CORRIGENDUM

Name of Work: Supply, installation, testing and commissioning of water supply pump work of F-type Residential Quarters at IITG Campus

NIT No.: IITG/IPM/NIT/C/2022-23/20 dated: 20.02.2023

Annexure-II

TITLE: General Layout Diagram for Hydro-Pneumatic System at IIT G Campus
 DWG NO. 1 A3
 SHEET 1 OF 1

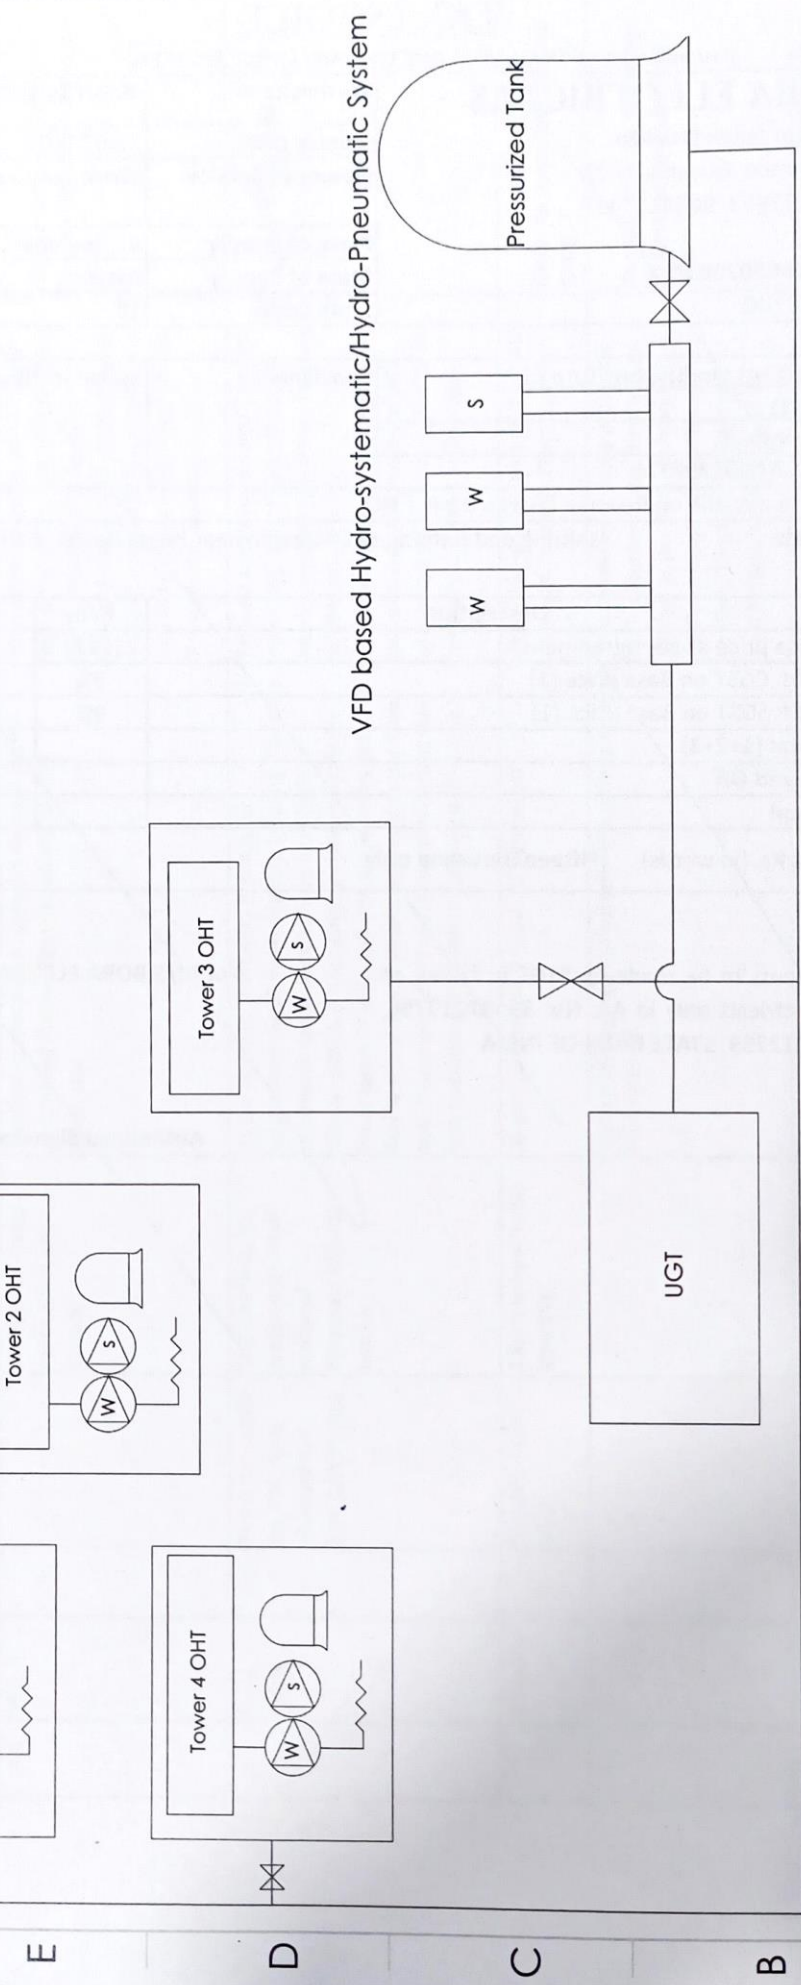
1.2					Is the pumping application is for closed loop or open loop system?	These pumps are being proposed for Residential water distribution system as per BOQ. It should then be Open loop system. Please confirm. This has an effect on hydrostatic head calculations.	Please refer to drawing at Annexure-I and it is open loop	
2	Tank	2	Pressure tank	100 litre Pressure tank	As per hydro-Pneumatic system, this tank is pneumatically pressurized over diaphragm bladder. BOQ is silent about the detailed specs.	This should be generally pressurized with dry Nitrogen only for Hydro-Pneumatic pumping system. Please confirm.	A VFD operated hydro-pneumatic system has a predefined Pressurized tank in its design and it is pre-charged by default.	
	Quantity			Each 1 shown in the quantity	As per description, it should be only one for all 3-pump sets. It should not be one each for 3-pumping set.	Please confirm.	Please refer to drawing at Annexure-I and comply to BOQ

Quantity		Each 4 shown in the quantity	As per BOQ description, it should be only one for all 2-pump sets.	Please refer to drawing at Annexure-I and comply to BOQ
5	I/T/C	5	Civil Foundation required Ant vibration Mount	BOQ is silent about it BOQ is silent about it.	Please visit site
			Quantity of detailed valves, NRV, Strainer, Piping material	Each Pump should have 2-valves, 1-NRV, 1 Strainer, 2-pressure gauges, 1-Purging valves at suction and discharge header. For Each pressurized tank, one supply, one drain valve and one purge valve are required. Incoming supply water valve is also required.	Refer to Point 5 in BOQ (Vendor Scope)
			Field Pressure sensor with control shielded FR copper cable for VFD control is required.	This is required as per system and BOQ is silent about it	Please confirm the scope.
			Cable supports above the ground inside the pump room	Please advise how to lay the cable for pumps. Cable tray is required or not, BOQ is silent about it	Kindly Review and confirm
